Access Compliance Report Public Rights-of-Way (Curb Ramps)

Main Street: **NARROW_CANYON_RD** Cross Street: **O_NEILL_DR** Location: **W**

ADA ID: **RPRK211027124936** Ramp Type: **Type 1 - Perpendicular** Initial Pass/Fail: **Fail** Overall Compliance: **No** Severity Score: **2**

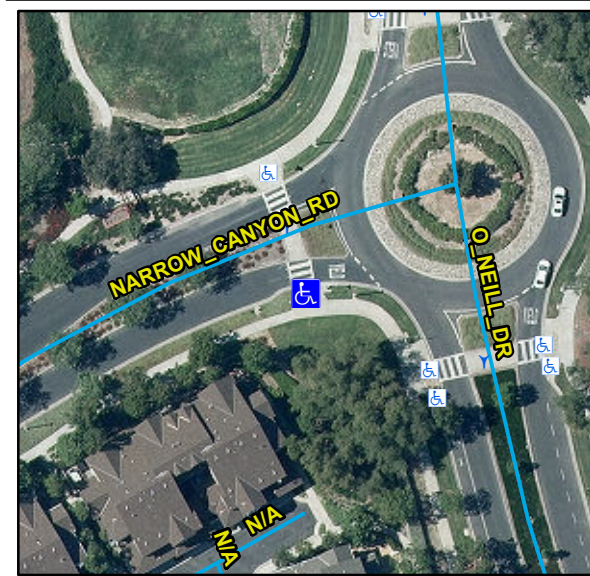
OC Std/PROW:
R304.2.2, R204.3, R304.5.3, STD 1115

Compliance	Description	Data	Compliance	Description	Data
N/A	Ramp Length (in)	113	N/A	Flare Type LT	
Yes	Ramp Width (in)	48			N/A
Yes	Ramp Run Slope (%)	7.1	N/A	Flare Slope LT (%)	N/A
No	Ramp Cross Slope (%)	3	N/A	Flare Traversable LT	N/A
N/A	Landing Present	N/A	N/A	Flare Type RT	
N/A	Landing Length (in)	N/A			N/A
N/A	Landing Width (in)	N/A	N/A	Flare Slope RT (%)	N/A
N/A	Landing Run Slope (%)	N/A	N/A	Flare Traversable RT	N/A
N/A	Landing Cross Slope (%)	N/A	N/A	DWS Provided	N/A
N/A	Landing Movement Obstructed?	N/A	N/A	DWS Contrast	N/A
	Landing Movement Type	N/A	N/A	DWS Length (in)	N/A
N/A	Landing Shared	N/A	N/A	DWS Full Width	N/A
N/A	Clear Space	N/A	N/A	DWS Offset Left (in)	N/A
N/A	Clear Space To Crosswalk (in)	N/A	N/A	DWS Offset Right (in)	N/A
N/A	Marked Crosswalk 1	Yes	N/A	Marked Crosswalk 2	N/A
	Crossing 1 Direction	N		Crossing 2 Direction	N/A
	Marked Crosswalk 1 Width (in)	144		Marked Crosswalk 2 Width (in)	N/A

N/A	Ramp Inside Crosswalk 1	Yes	Yes	Ramp Inside Crosswalk 2	N/A
	Crossing 1 Slope (%)	1.6		Crossing 2 Slope (%)	N/A
	Crossing 1 Cross Slope (%)	2.1		Crossing 2 Cross Slope (%)	N/A
N/A	Gutter Ponding	N/A	No	Curb Slope	12.4
Yes	Gutter Lip Height (in)	0		Road Run Slope (%)	N/A
N/A	Gutter Run Slope (%)	N/A		Road Cross Slope (%)	N/A
N/A	Gutter Cross Slope (%)	N/A			
Yes	Overall Surface Condition: Acceptable		No	Perp Joint Present	No
	Cross Gutter Present?	No		Spandrel Present?	No
	Replace Cross Gutter?	N/A		Replace Spandrel?	N/A

Possible Solutions:
Remove & Replace Entire Ramp.
